PREVOST SAFETY RECALL SR22-05 NHTSA SAFETY RECALL #22E-030 September 2023

IMPORTANT SAFETY RECALL – SECOND NOTIFICATION

DEFECTIVE BELT IDENTIFICATION:

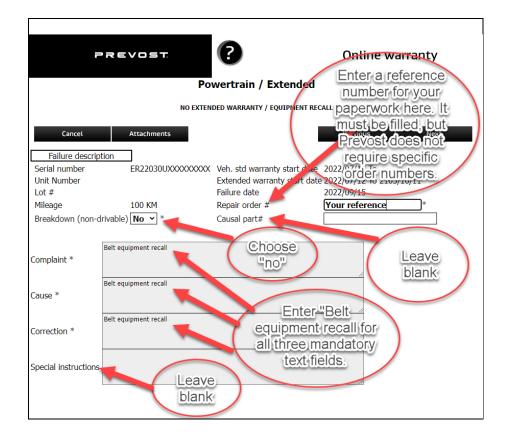
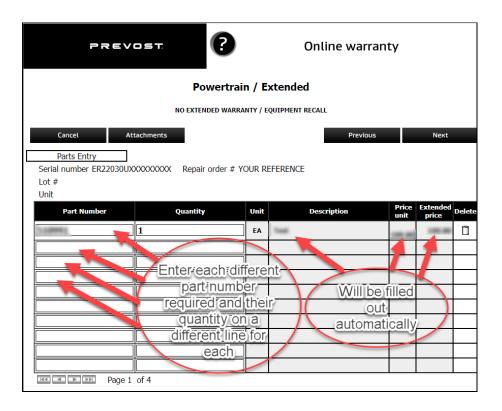
Defective Aramid cord reinforced belt (left) vs New polyester cord belt (right) – Note the different cord arrangement between the two belt types.

For all non-installed belts, new replacements are now available through the Prevost Part network (see appendix 1 for defective belt vs new belt identification).
